**Re: Well #1 ([YAMH53009](#)), well #2 ([YAMH59102](#)), three 4,000-gal tanks, one 20,000-gal tank, pressure tanks, and UV & cartridges for secondary treatment
Soter Vineyards (PWS ID# [95701](#))
Conditional Approval ([PR#19-2023](#))**

Conditional Approval PR #19-2023 – 2 wells, storage tanks, UV & cartridge (secondary treatment)

Approximate 50- and 100-ft radii around SRC-BA (New Well)

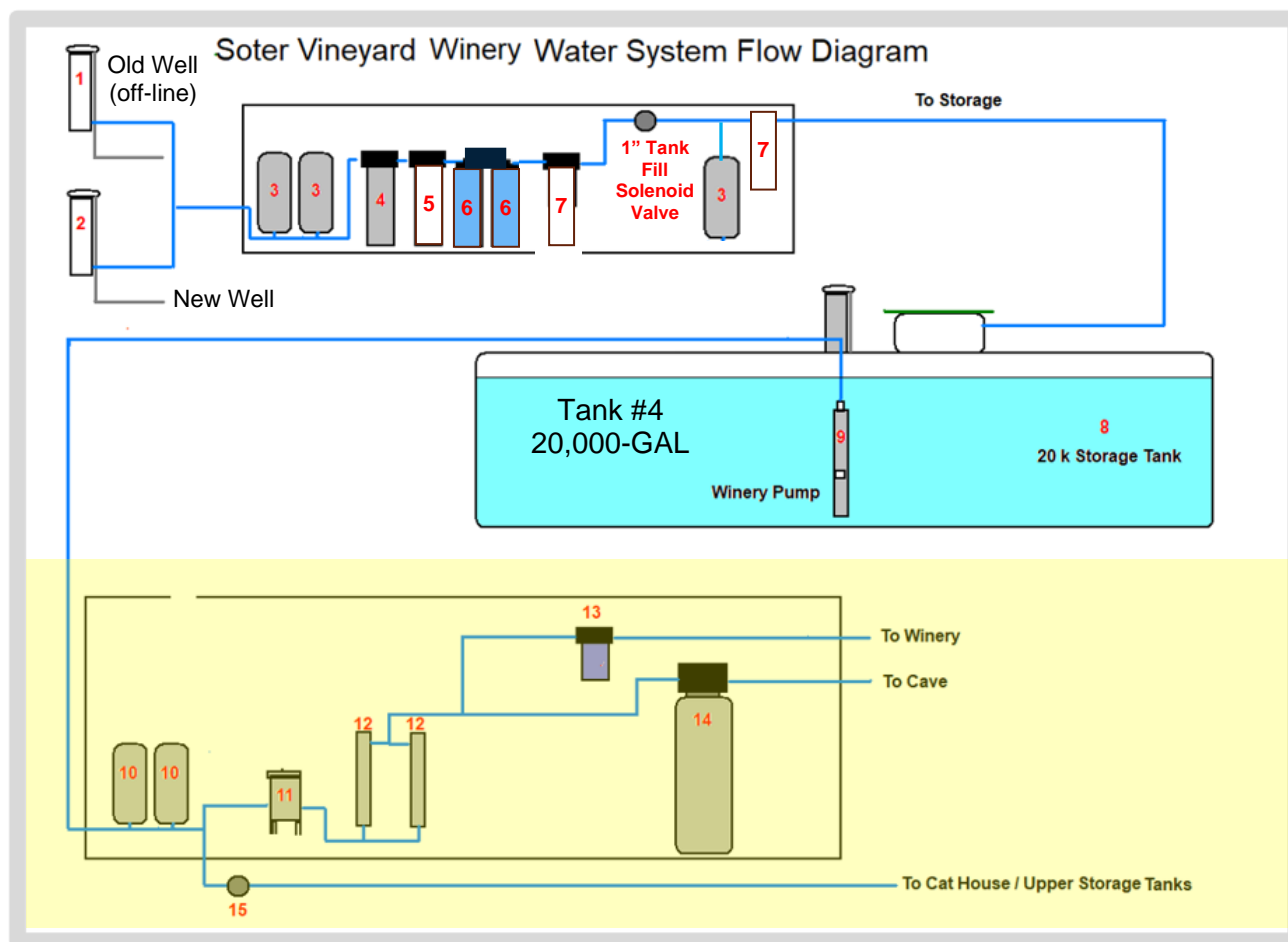
3. ☐ **Wells are protected from contamination from the roadway (located within 100-ft of the new well) and other hazards as listed in OAR 333-061-0050(2)(a)(E).** The information submitted did not show setbacks from the wells. Specifically, please provide a statement that there are no pressure sewer lines or septic drain fields within 50 feet of the well and no gravity sewer lines, or septic tanks within 100 feet of the well. Although a roadway appears to be located within 100 feet of both wells, since the wells are drilled into confined aquifers and located near a road, OAR 333-061-0050(2)(a)(D) applies. This rule allows DWS to waive the setback requirement for a road that is located within 100' of a well. To approve this setback issue, information must be submitted that demonstrates how the well is "...protected against contamination from surface runoff or hazardous liquids which may be spilled on the roadway and is protected from unauthorized access". More information about requesting waivers from construction standards is provided following this list of conditions.
